UNITED STATES PATENT AND TRADEMARK OFFICE

APPLICATION NO.	FILING DATE	FIRST NAMED INVENTOR	ATTORNEY DOCKET NO.	CONFIRMATION NO.
10/572,378	03/16/2006	Kazuyoshi Koizumi	NIF-107	5660
33628 7590 12/09/2009 KANESAKA BERNER AND PARTNERS LLP 1700 DIAGONAL RD SUITE 310 ALEXANDRIA, VA 22314-2848				
EXAMINER RASHID, MAHBUBUR				
ART UNIT 3657		PAPER NUMBER		
MAIL DATE 12/09/2009		DELIVERY MODE PAPER

Office Action Summary

DETAILED ACTION

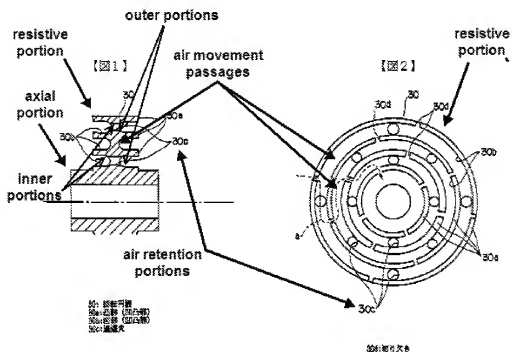
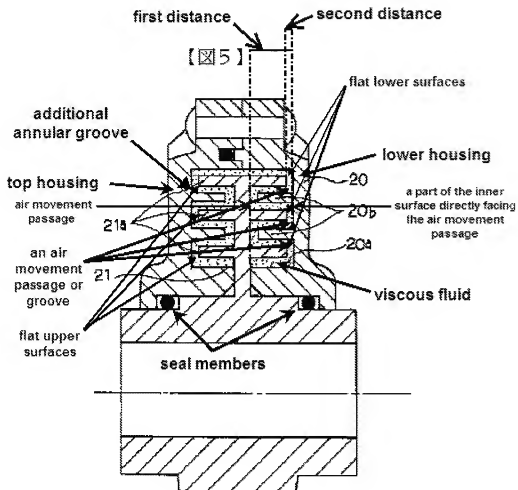
a rotor (see fig. 1, (1)) disposed inside the housing and having an axial portion (21) projecting from the housing, and a circular resistive portion (30a) which moves through said viscous fluid inside said housing, said rotor (1) having a smooth outer periphery extending continuously without interruption (see figs. 1 and 2) and flat upper and lower surfaces without a projection (see 2nd figure above); and

wherein said resistive portion (30a) includes multiple air retention portions (30C) provided annularly and intermittently around the axial portion thereof, and the housing has air movement passage (see 2nd figure above) connecting two of the air retention portions.

Regarding flat upper and lower surfaces, JP '760 discloses flat upper and lower surfaces of the rotor without a projection and clearly shown in figs. 1 and 5 and the figures above.

Regarding the air movement passage, JP '760 discloses annular air movement passage (fig. 5 and figures above) that connects at least two of the air retention portions (30c) of the rotor.
